Second Preliminary Consultation  
**MONTGOMERY COUNTY HISTORIC PRESERVATION COMMISSION**  
**STAFF REPORT**

<b>Address:</b>	10221 Menlo Ave., Silver Spring	<b>Meeting Date:</b>	8/14/2024
<b>Resource:</b>	1870-1916 Capitol View Park Historic District	<b>Report Date:</b>	8/7/2024
<b>Applicant:</b>	Kenneth A. Gear	<b>Public Notice:</b>	7/31/2024
<b>Review:</b>	Preliminary Consultation	<b>Staff:</b>	Dan Bruechert
<b>Proposal:</b>	Construction of New Single-Family House Construction

*Figure 2: Revised design showing the front and left-side elevations.*

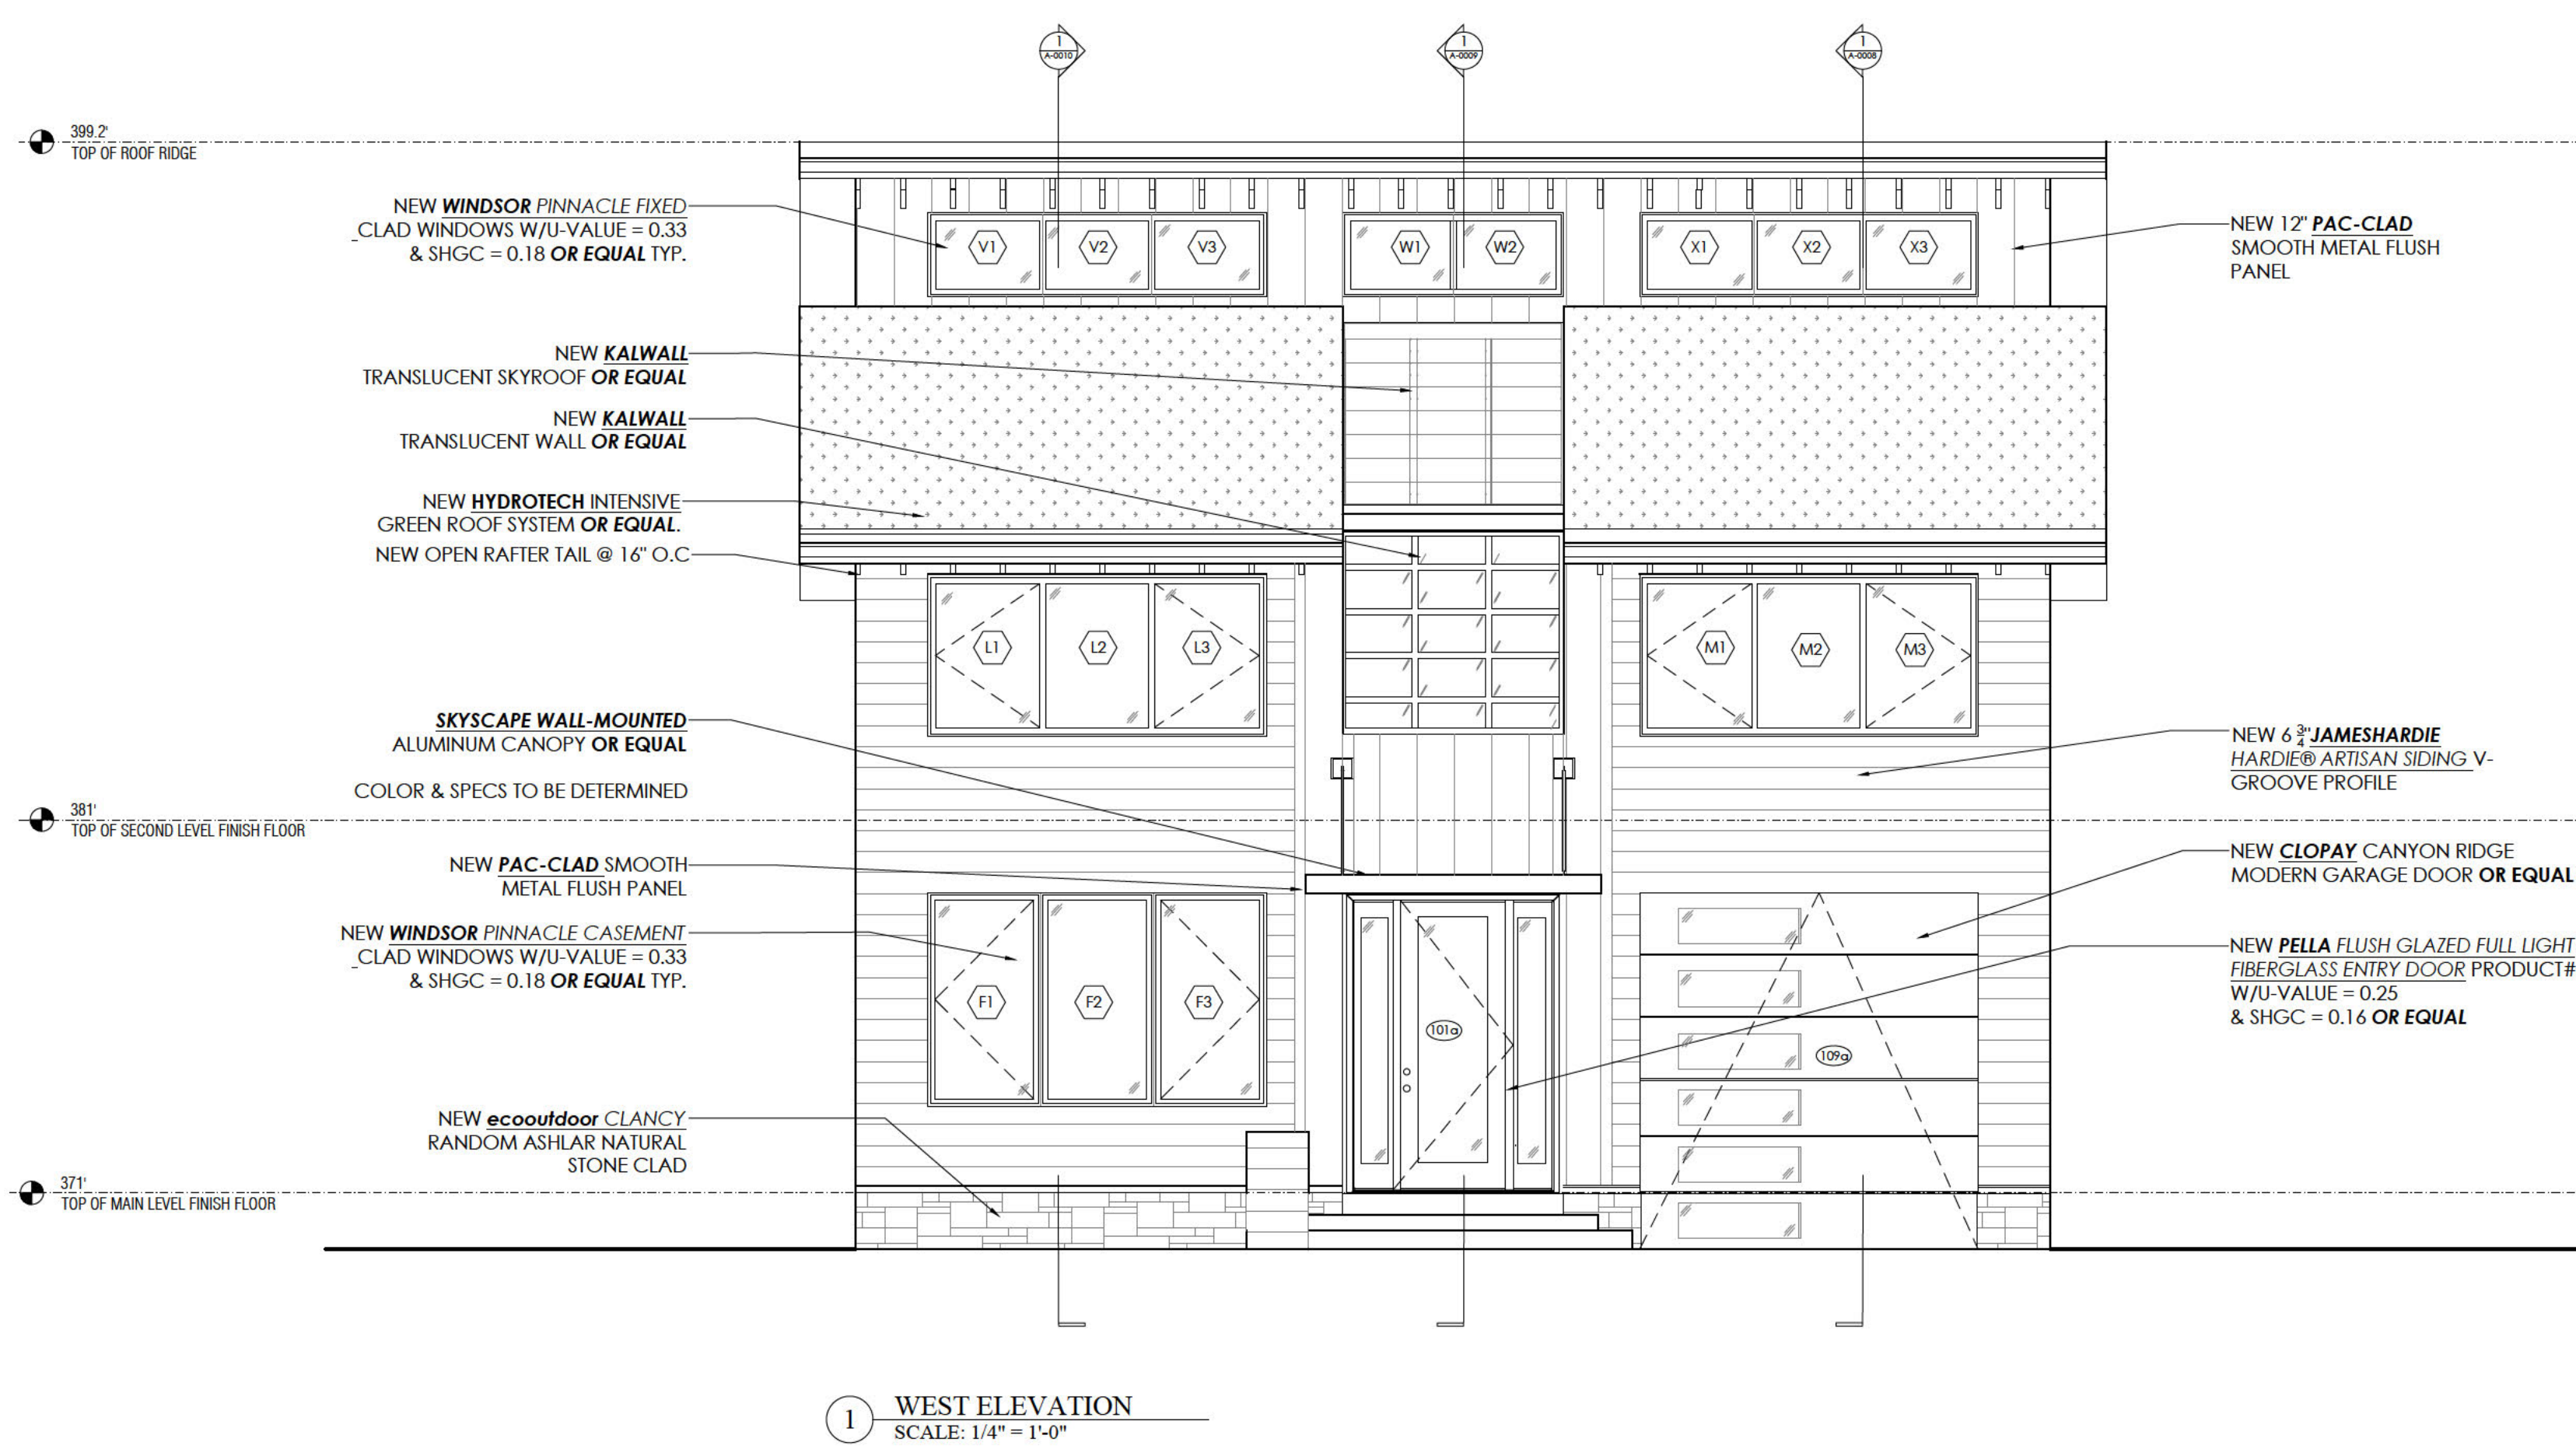
Staff finds the proposed design, though distinctly contemporary, will not detract from the character of the surrounding district. The roof form, window size and scale, and green roof are all intended to stand apart from the historic buildings and historic building styles found throughout the historic district. However, Staff finds the proposed house's siting, massing, proportions, and materials (all discussed below) and not its stylistic elements are what makes the proposed design appropriate under Standard 9 which encourages compatibility while differentiating between new and historic elements.

One of the critiques of the design presented at the January 2024 Preliminary Consultation voiced by a number of commissioners, was that the fenestration on the front elevation appeared unbalanced and that the overall fenestration appeared disjointed and hindered creating a cohesive whole. The revised design balances the width of the front elevation opening, and stacks the openings, but Staff notes these are wider openings than are typically found throughout the historic district and creates an appearance with a more highly glazed percentage of wall surface. While Staff also notes that the window openings on the other elevations are stacked, the proposed window sizes are irregular. Staff requests feedback from the HPC on the appropriateness of the fenestration size and arrangement.

*Figure 3: Right-side and rear elevations including the proposed patio.*

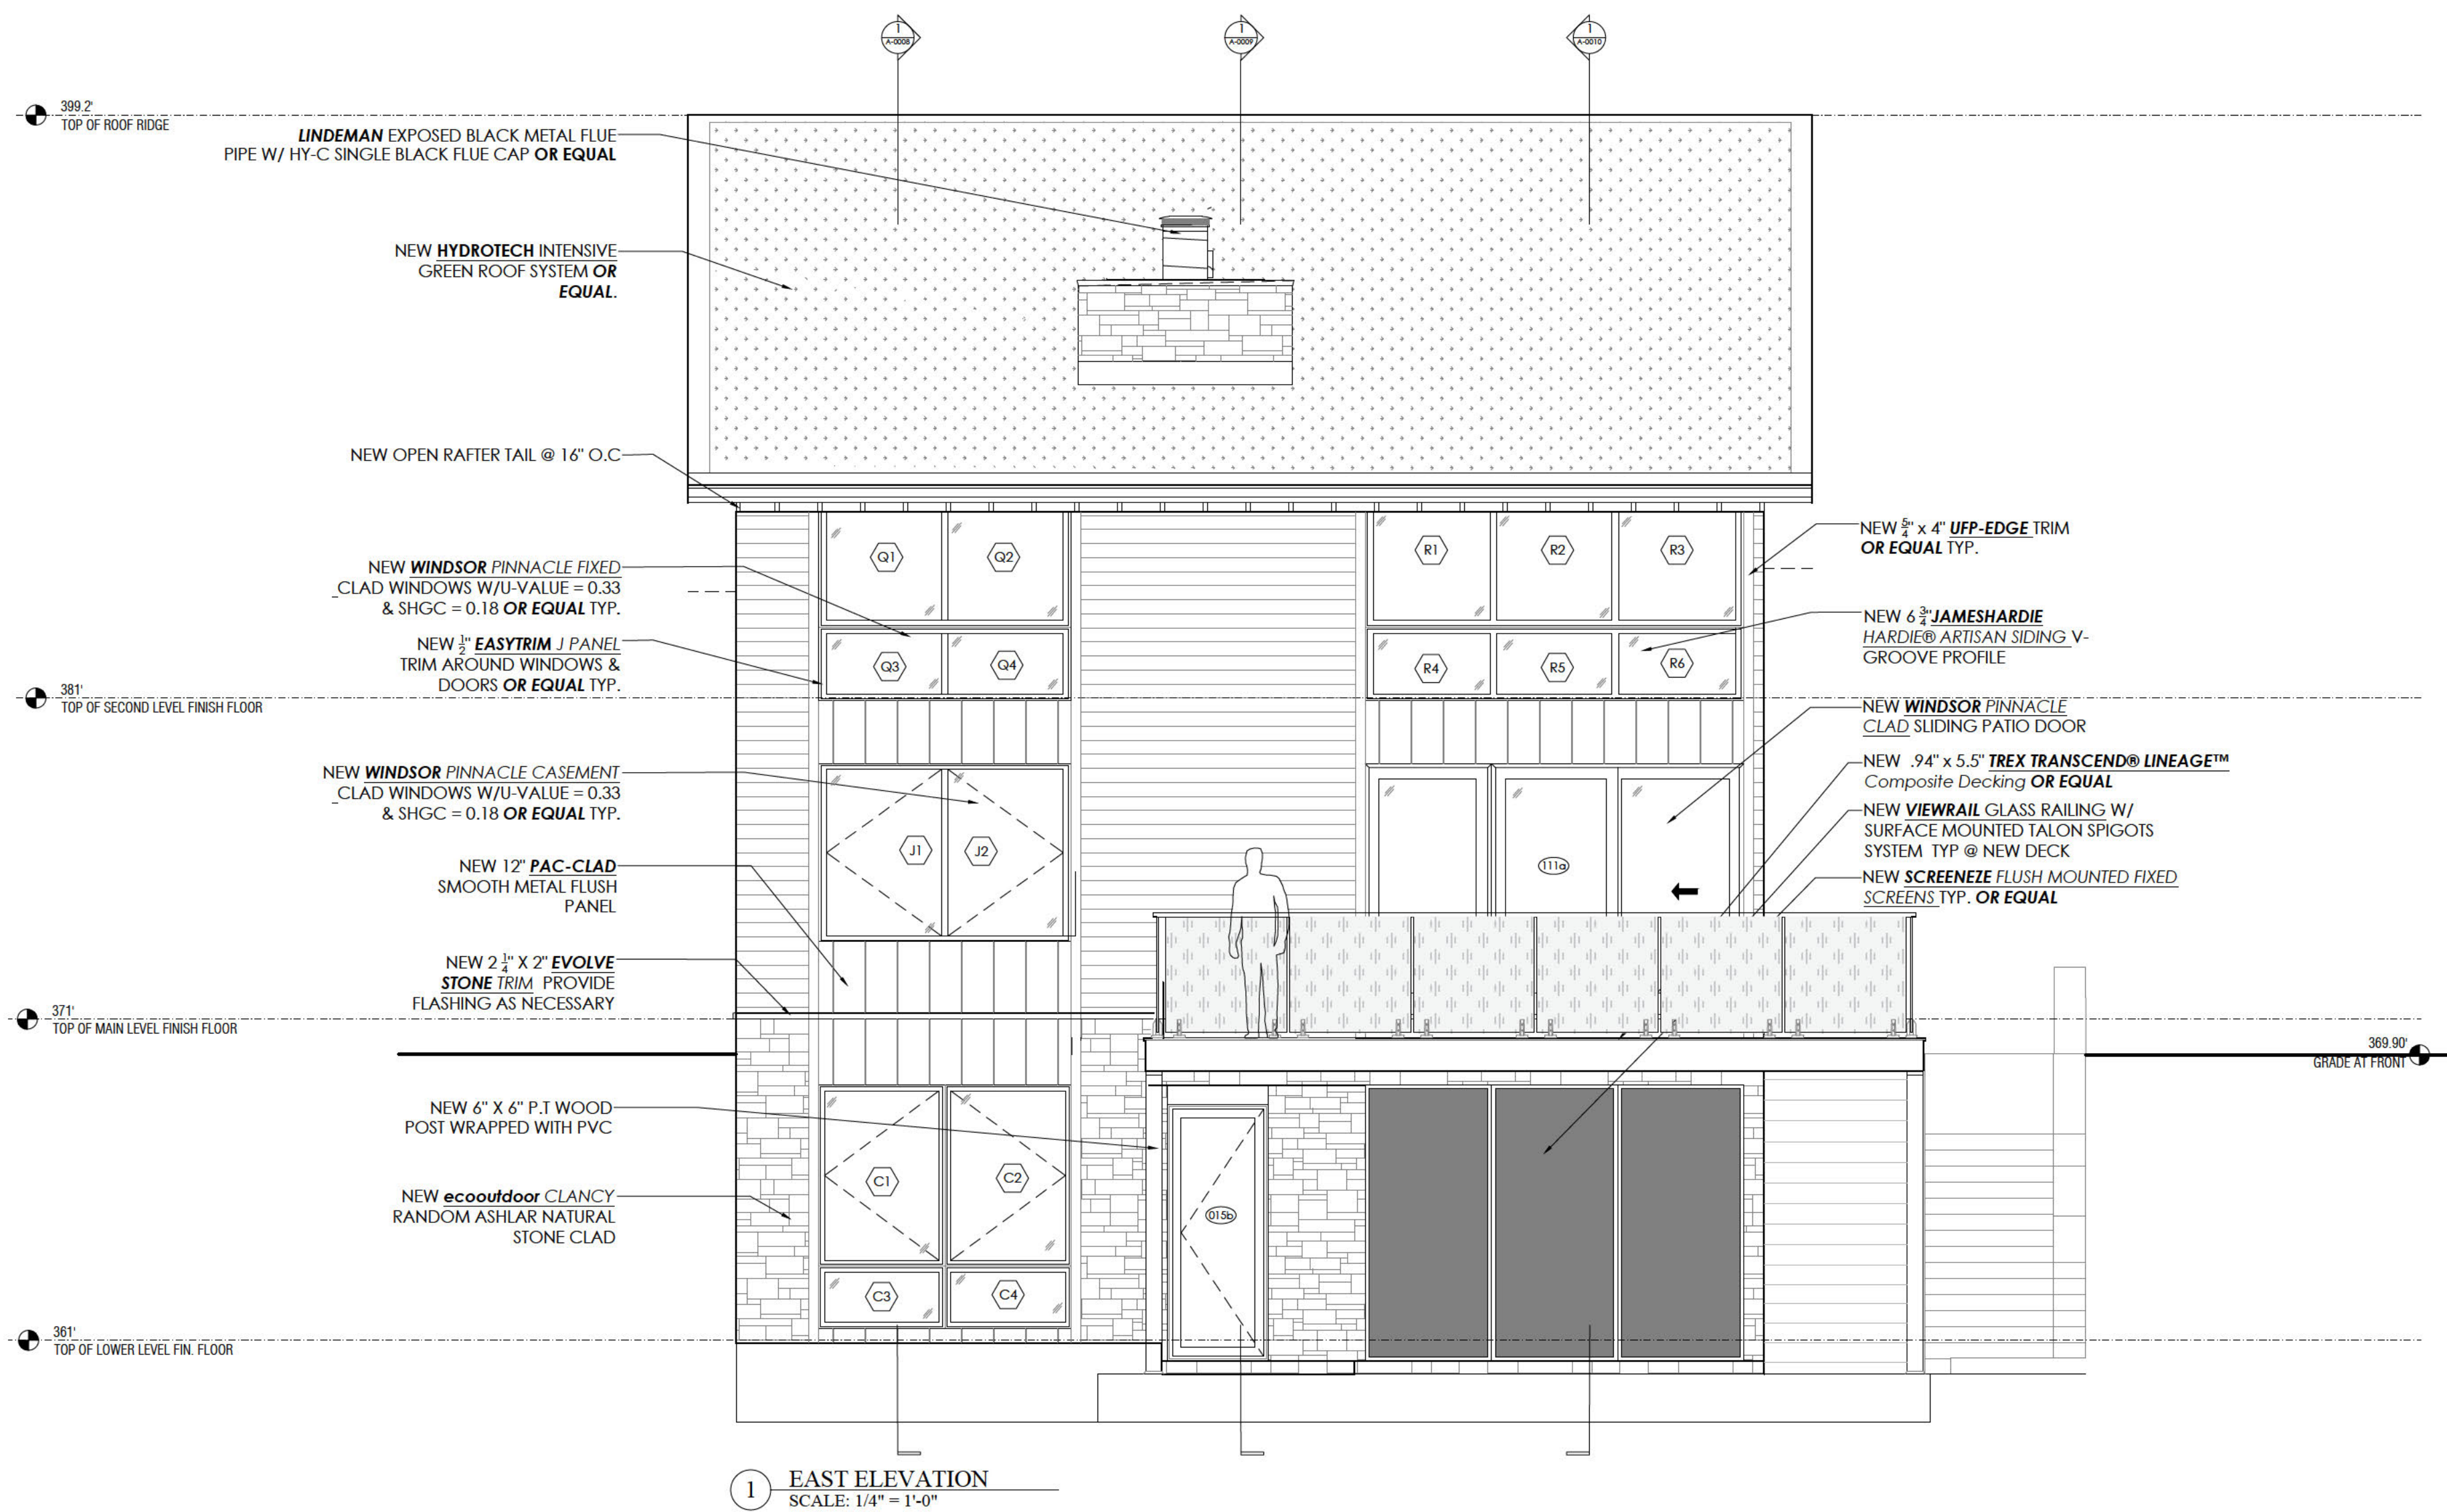
Most of the design elements for the proposed house have been revised from what the HPC reviewed in the January 2024 Preliminary Consultation. The new design includes a monitor roof composed of two shed roof planes. The rear roof plane projects above the lower front roof plane, creating a monitor or clerestory facing west (the front elevation). The house has a central entrance with a one-bay garage on the right. A window, matching the width of the garage door, is proposed to the left of the front door. Second-floor windows are proposed over the first-floor openings. Over the front door, the applicant proposes to install a 'Kalwall' translucent window panel, that bisects the front roof plane. The house will be covered in fiber cement siding, with selections of PAC-CLAD metal panels. The applicant proposes to install a green roof on both roof planes. The rear elevation of the house is mostly glazed, with a rear deck. Below the deck, there is a walk-out patio. The patio appears to be approximately 35' (thirty-five

feet) deep, narrowing to approximately 15' (fifteen feet). No material is identified for the proposed patio.
